JUMBO MINING CO.

Re: Drum Mine, M/027/007; Revised Notice of Intent; Mizpah Pit

MINERALS PROGRAM
Large Mine NOI Deficiency Review

MIZPAH PROJECT COMMENTS

MAF R613-004-105.2

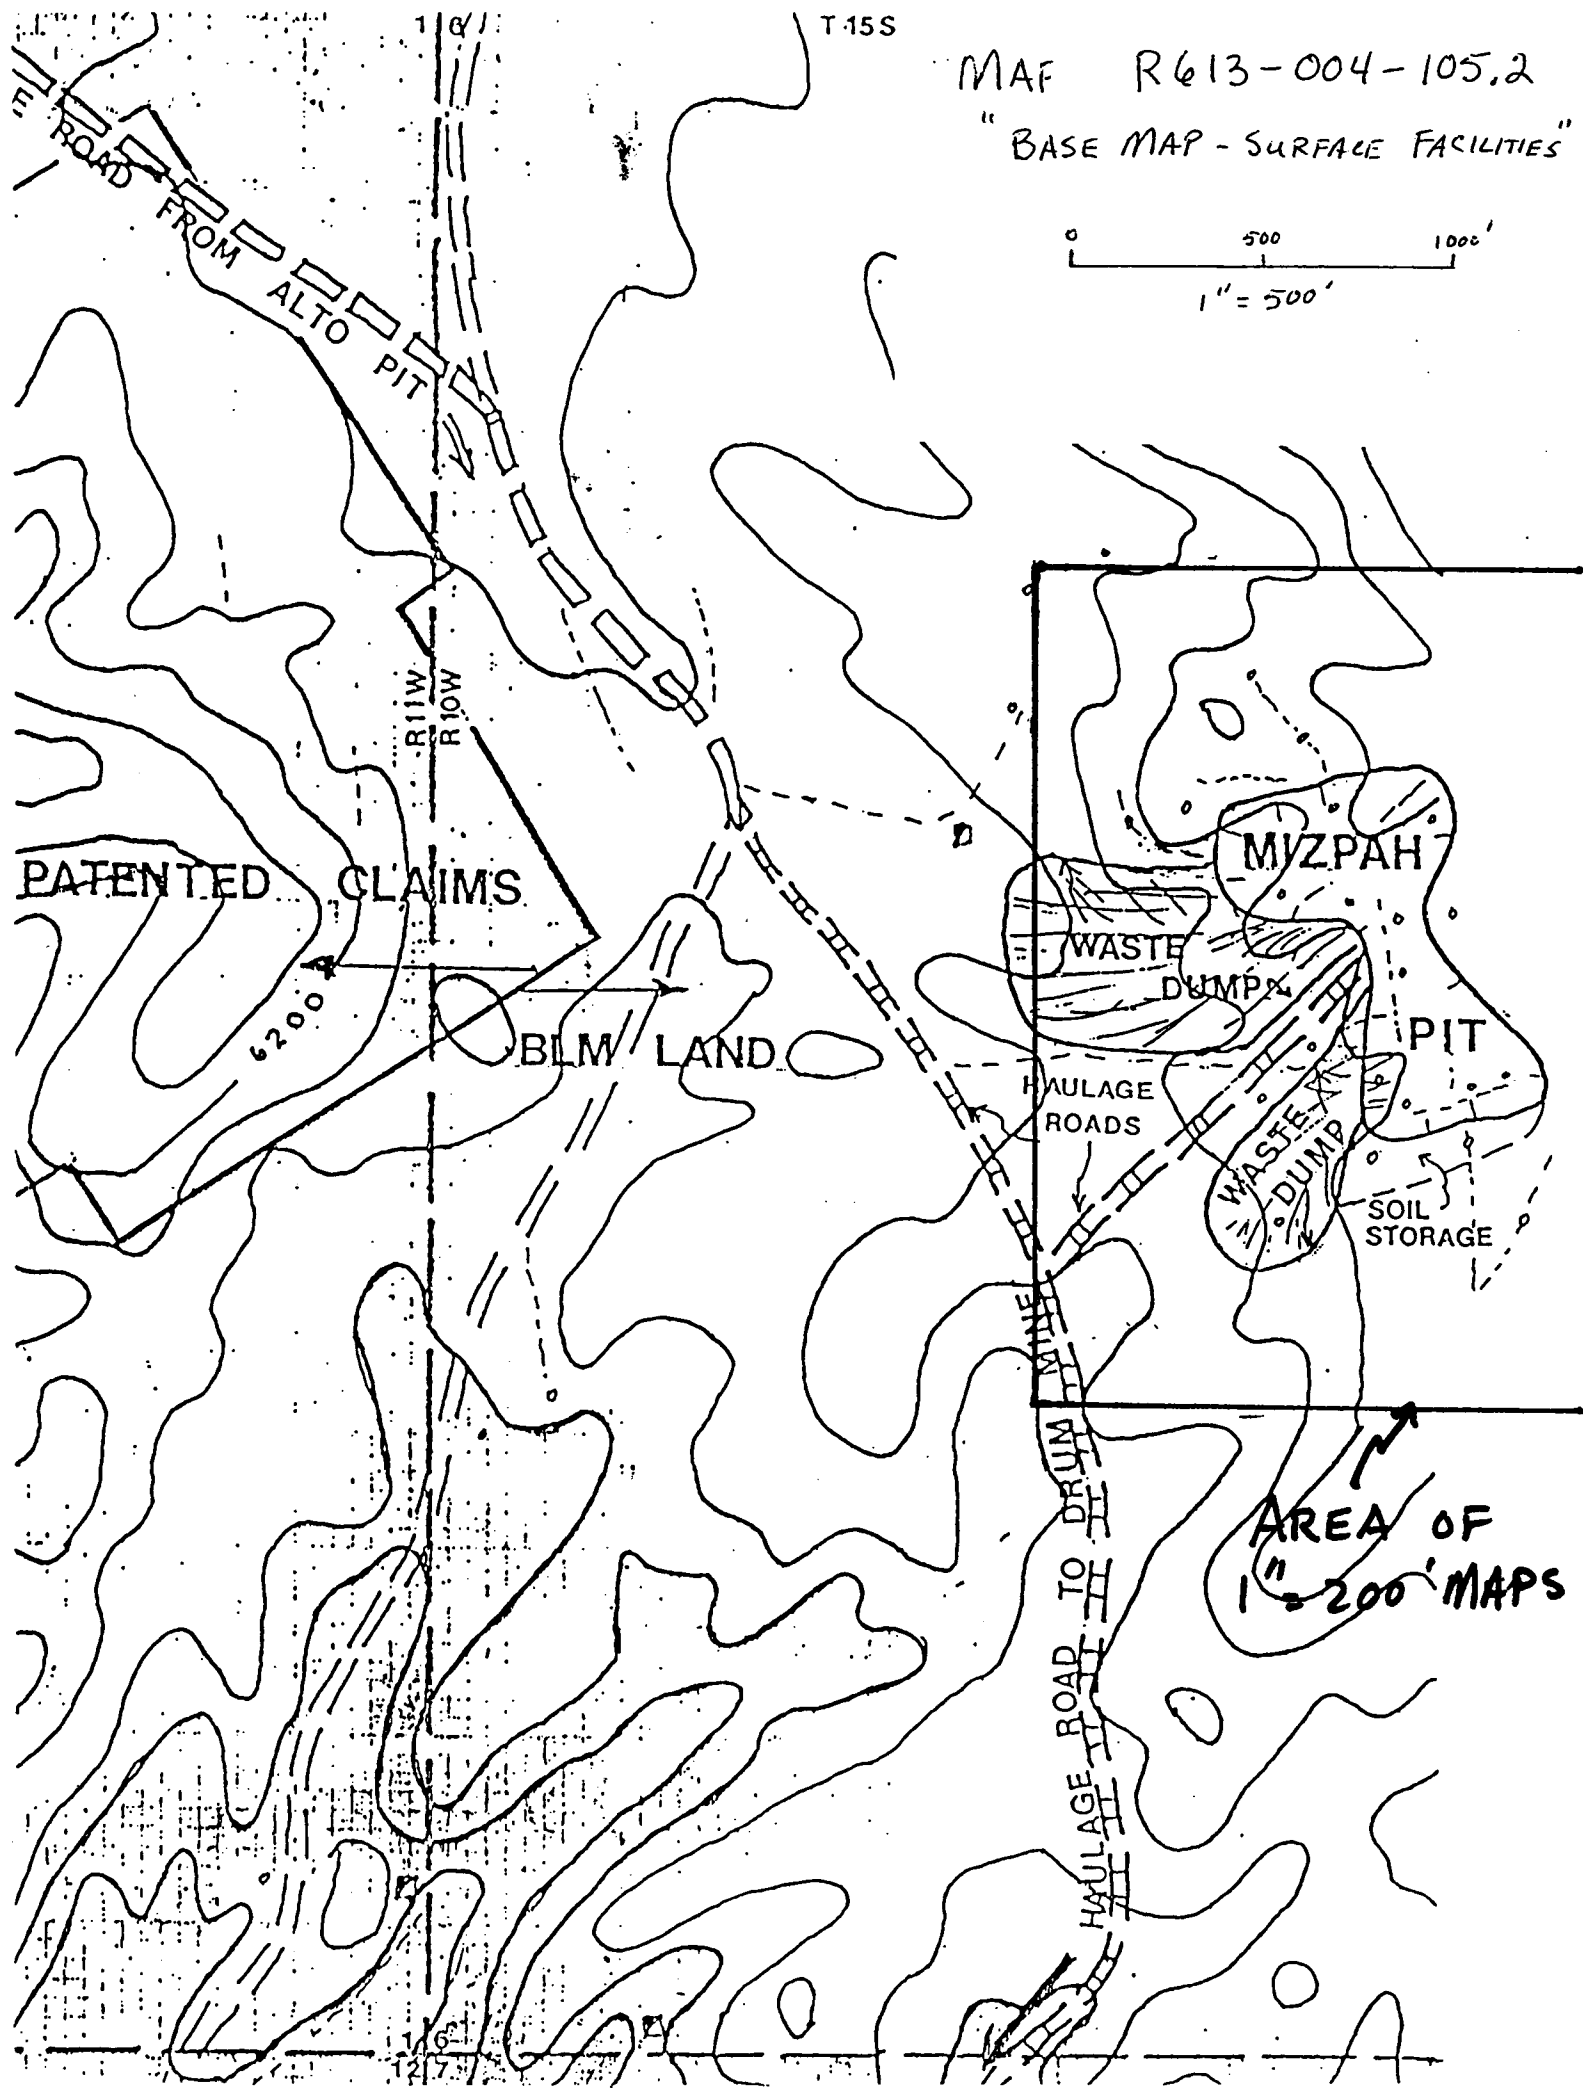
105.1	_____
105.1.11	_____
105.1.12	_____
105.1.13	_____
105.1.14	<u>X</u> ✓
105.2	<u>X*</u> ✓
105.2.11	_____
105.2.12	_____
105.3	_____
105.3.11	<u>X</u> NO MAP NEED ✓
105.3.12	_____
105.3.13	_____
105.3.14	<u>X</u> ✓
105.3.15	_____
105.3.16	<u>X</u> ✓
105.3.17	<u>X</u> ✓
105.3.18	<u>X**</u> ✓
105.4	_____

* No scale or key indicated on map provided.

- (1) REG. R613-004-104
See Map R613-004-104 "Surface & Mineral Ownership"
- (2) REG. R613-004-105.1.14
See Map R613-004-105.1.14 "Previous Disturbed Areas"
- (3) REG. R613-004-105.2
See Map R613-004-105.2 "Base Map - Surface Facilities"
- (4) REG. R613-004-105.3.11
No map needed because all regraded waste dump slopes will
be less or equal to 2h:1V slope
- (5) REG. R613-004-105.3.14
See map R613-004-105.3.14 "Area To Be Disturbed But Will
Not Be Reclaimed"
- (6) REG. R613-004-105.3.16
See Map R613-004-105.3.16 (A),(B),(C)
 - (A) "Geology - Structure Map"
 - (B) "Topsoil Location Map"
 - (C) "Vegetation Survey Map"

MAP R613-004-105.3.18(A)

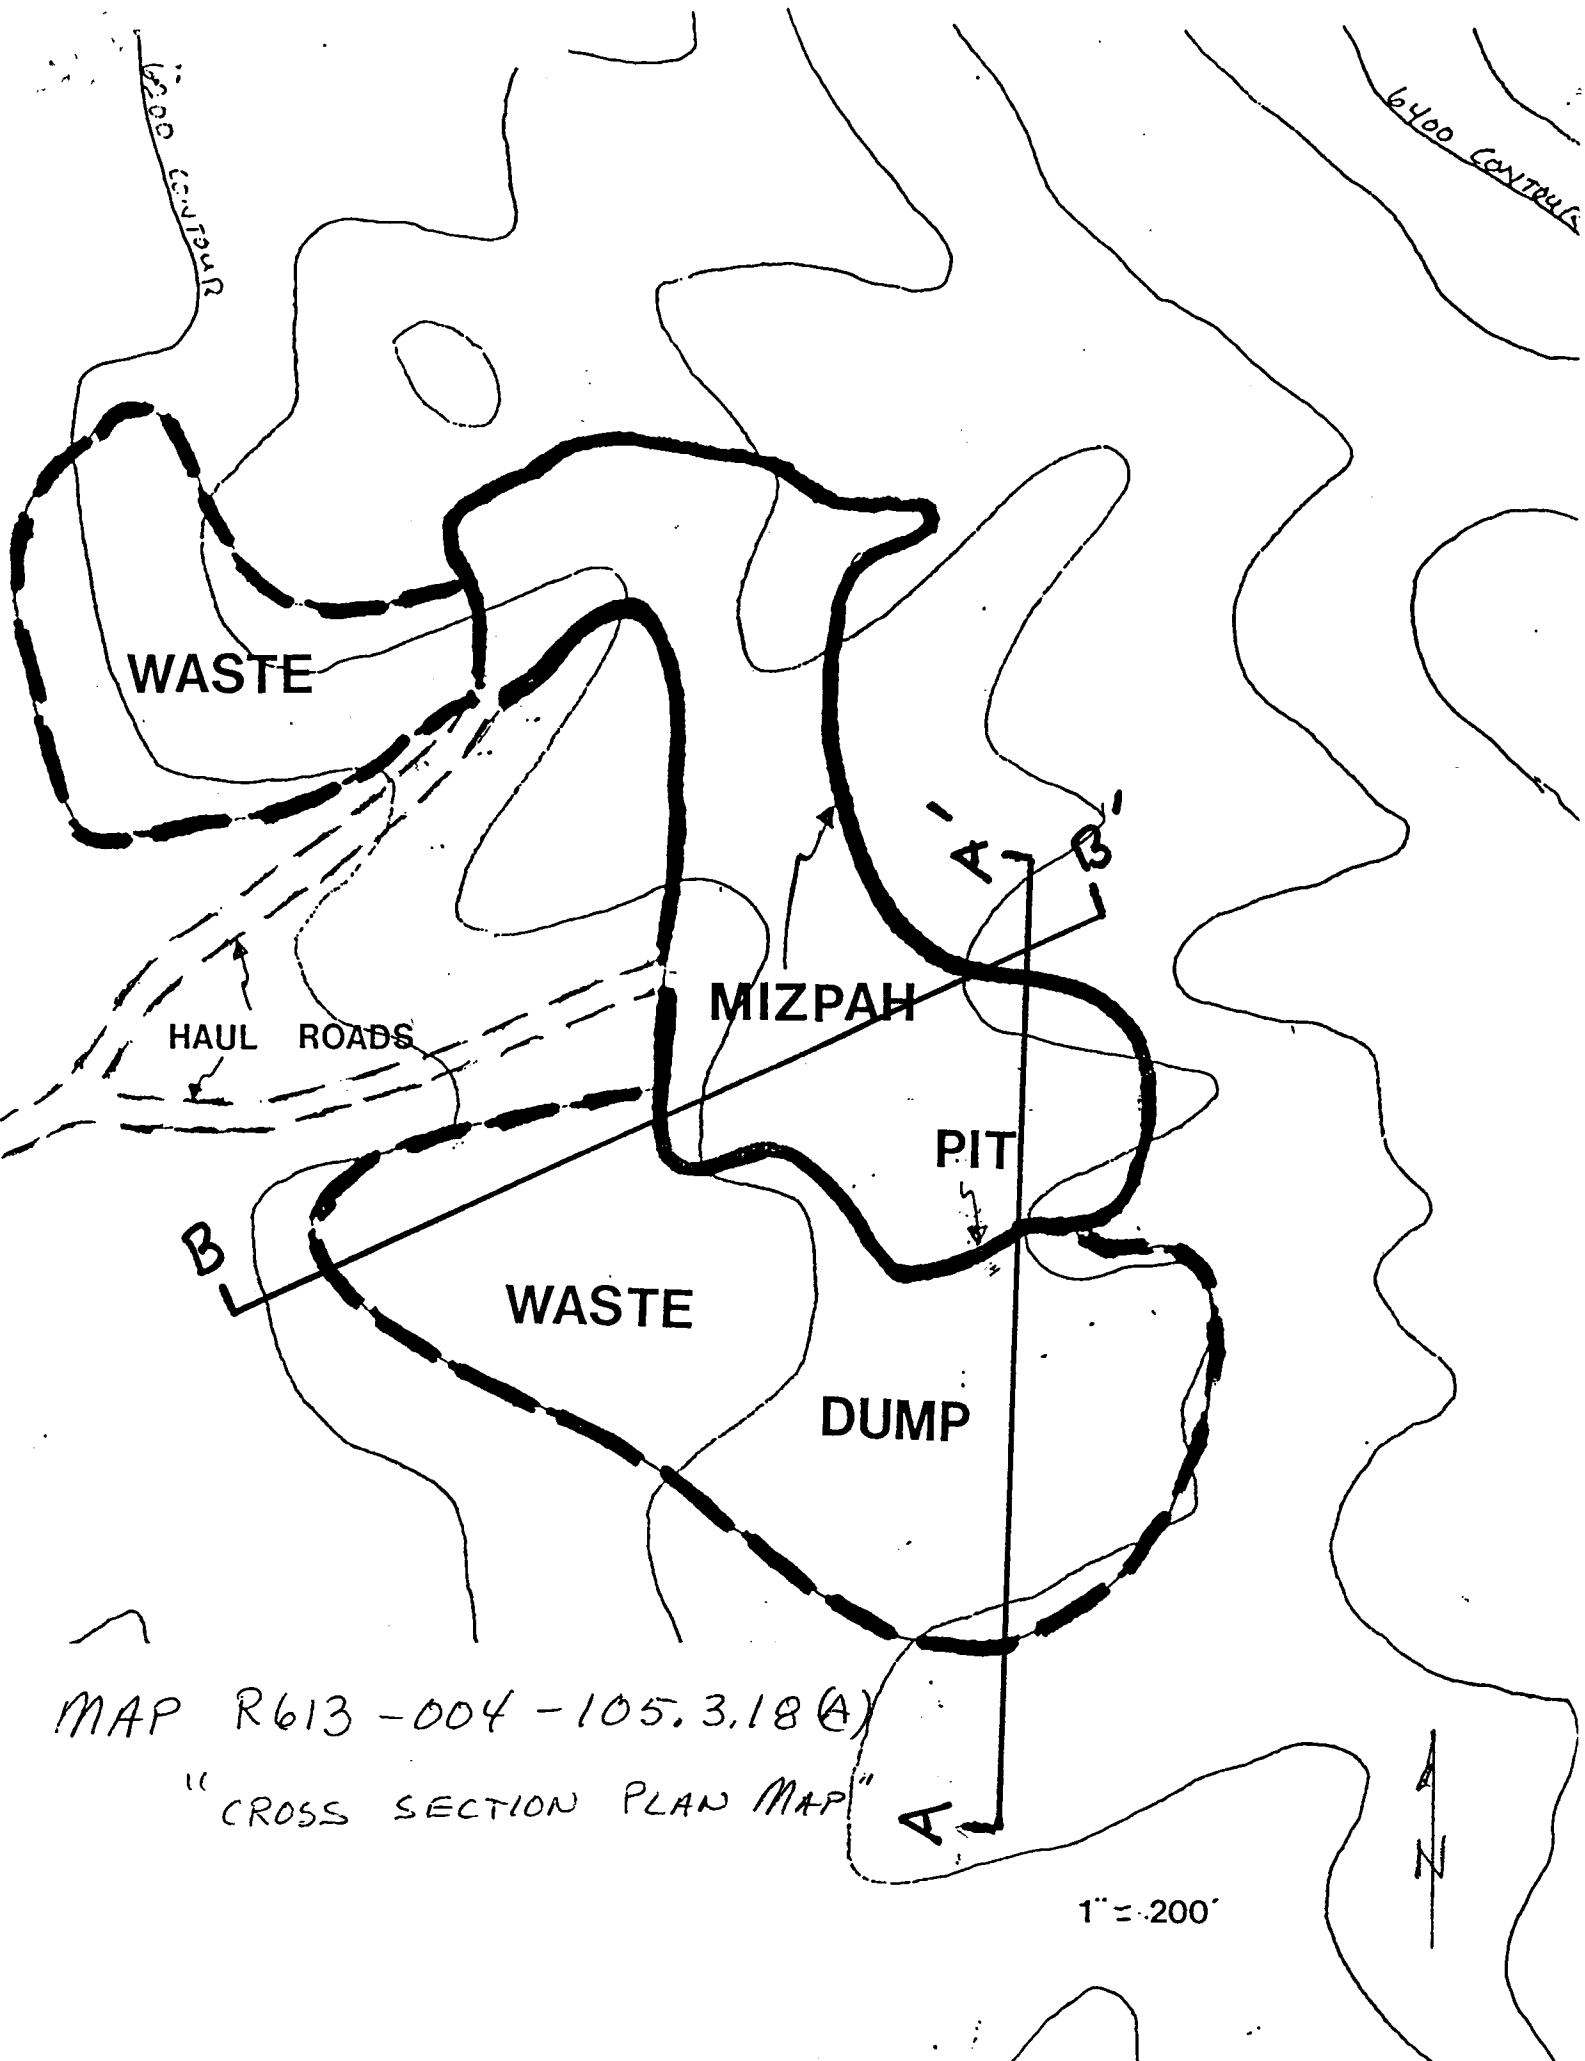
** Anticipated post-mining pit configuration design drawing details and typical x-sections.

(8) REG. R613-004-105.3.18 (A) & (B)

See Map R613-004-105.3.18 (A) & (B)
"Post Mining Pit Configuration"

(A) - Cross-section Plan Map
(B) - Cross-section A-A' & B-B'
